ORDINANCE 99-17

TO AMEND THE PRELIMINARY PLAN FOR PARCEL H OF THE CANADA FARM
PLANNED UNIT DEVELOPMENT (PUD)

Re: 3809 South Sare Road
(Ken Blackwell, Petitioner)

Subject: Case # PUD-10-99

POD-10-99
Site Plan Showing
Pathway

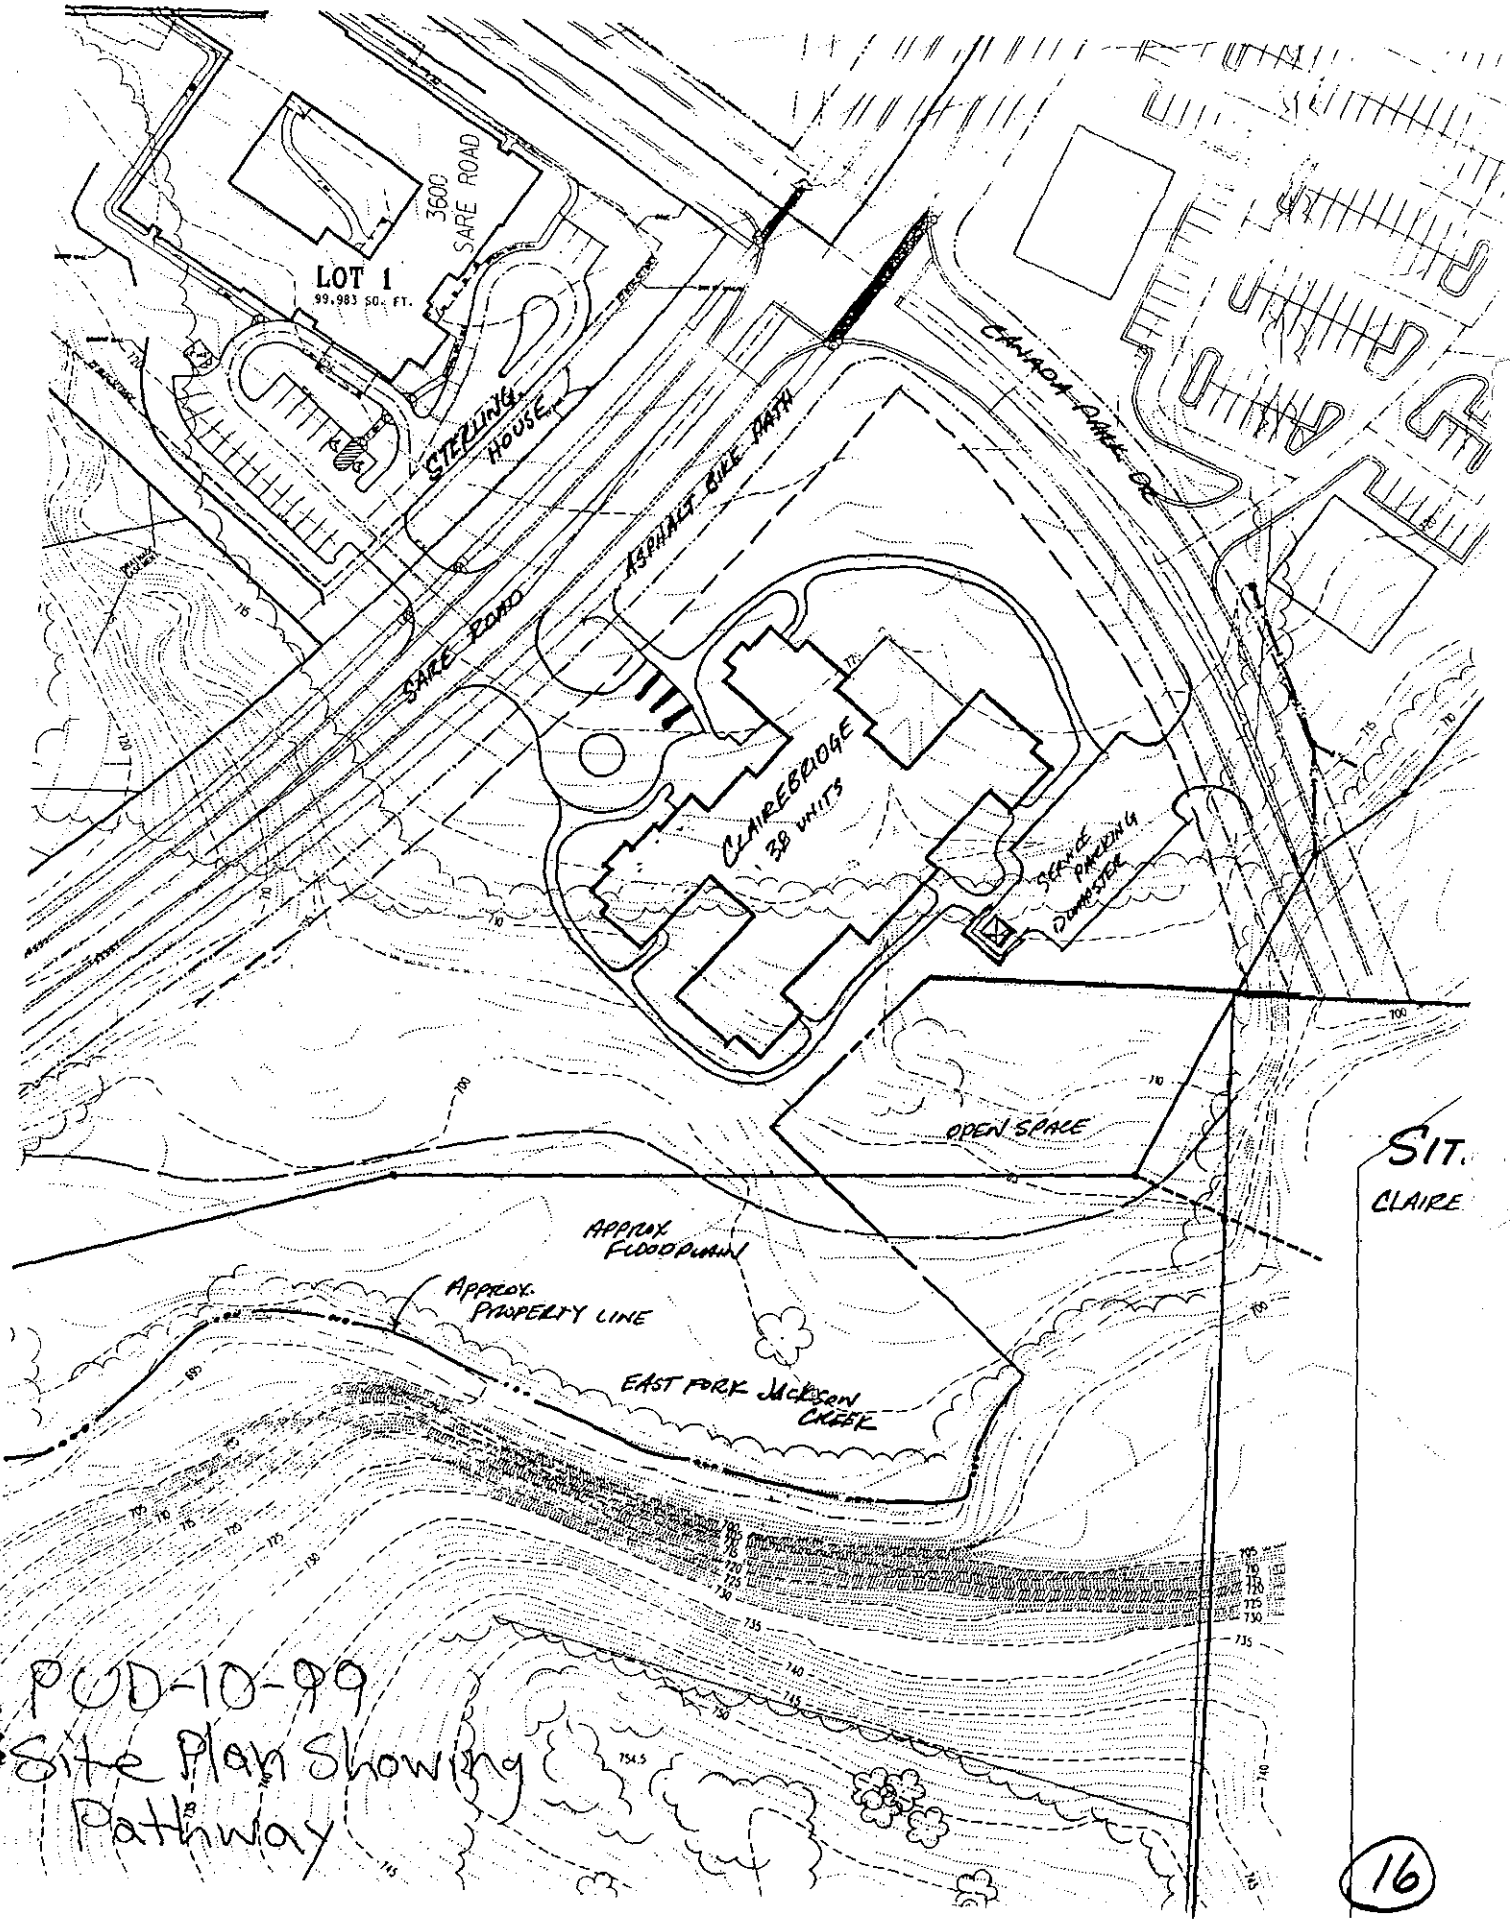
d. **Pedestrian Accommodations:** Per staff's request, the petitioner has designed a pathway system which will allow residents to walk around the perimeter of the building as well as enjoy the available open space at the rear of the property along the east fork of Jackson Creek.

3. Earth berms with landscaping will be used to buffer entry drop-off zone and guest parking. A sample will be shown for the staff's review.
4. Based on the staff's recommendation, a pathway system around the site to the greenway system will be shown.
